SERVICE LETTER 138

10000 and 13000 Nose Gear End Cap Cracks

Aircraft Makes/Model(s):	Float Model(s):	Compliance: Mandatory	By: MAS
Air Tractor AT-802A & AT-802, DeHavilland DHC-6	10000A & 13000A	Part Number: 1003610	Approved: DRH
		Date: 8/25/2026	Revision: E

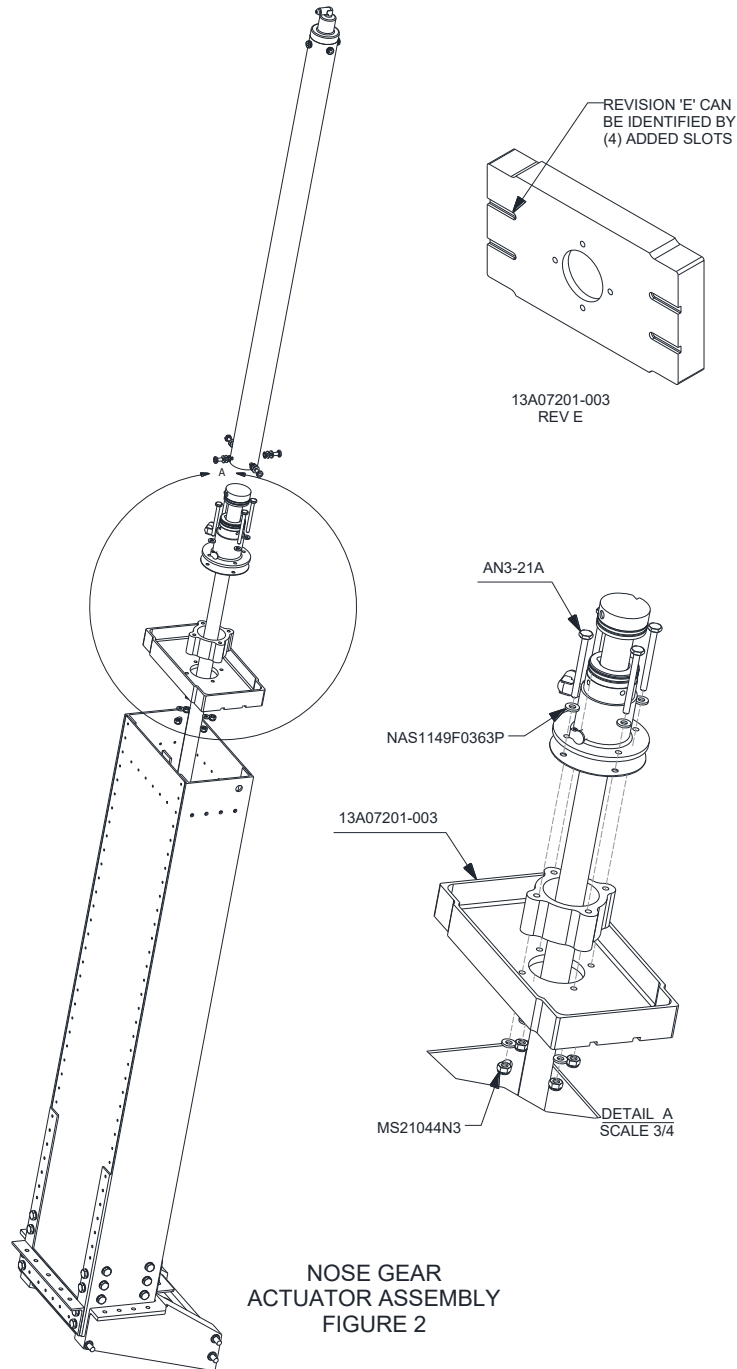
NOTES: Figure 1 shows the part that is cracked, and Figure 2 shows its location on the nose box assembly. This is the forward side of the part which can be seen looking into the open (front) end of the nose gear box. No disassembly should be required to examine this area. The area should be thoroughly cleaned before inspecting. Use good lighting. If in doubt, dye penetrant inspection can also be accomplished.

If evidence of cracking is found in Nose Box End Cap either by visual or dye penetrant inspection per Figure 1, the following instructions will be accomplished to replace damaged Nose Box End Cap:

1. Position aircraft safe for maintenance.
2. Support aircraft on jacks so that there is no weight on float landing gear.
3. Remove forward float deck access cover to access Nose Box End Cap.
4. Pull "PUMP 1" and "PUMP 2" Circuit Breakers and move Gear Selector to center position to relieve hydraulic pressure.
5. Disconnect Hydraulic Fitting on Nose Gear Actuator. Cap plug and fittings.
6. Remove Nose Gear Box Assembly per Maintenance Manual. Save hardware for reinstallation.
7. Remove bolts (4) and washers (4) from Hydraulic Actuator Cylinder and separate from Nose Box Assembly.

8. Disconnect and remove Hydraulic Ram from Nose Gear Rod End by rotating counterclockwise. Count threads showing on Nose Gear Rod End for reinstallation.
9. Remove Bolts (4), washers (4), and Nuts (4) from Cylinder Flange Assembly.
10. Remove Cylinder Flange Assembly, Flange Plate, and Flange Cylinder Nose Gear Ram Spacer.
11. Drill out all rivets securing Nose box End Cap and remove.

12. Install Nose Box End Cap and back drill, using #30 drill bit, for initial fitment.
13. Remove Nose Box End Cap and remove any burrs left from back drilling.

14. Apply a thin coat of Sealant to End Cap surface that will contact the Nose Box Assembly.
15. Reinstall Nose Box End Cap and Secure top and bottom of Nose Box with MS20470AD5 or AD6 rivets and sides of Nose Box with MS20426AD5 or NAS1097AD6.

16. Apply a thin coat of Sealant to Cylinder Flange Assembly, Flange Plate, and Flange Cylinder Nose Gear Ram Spacer mating surfaces and reinstall with replacement AN3-21A Bolts (4), washers (4), and Nuts (4).
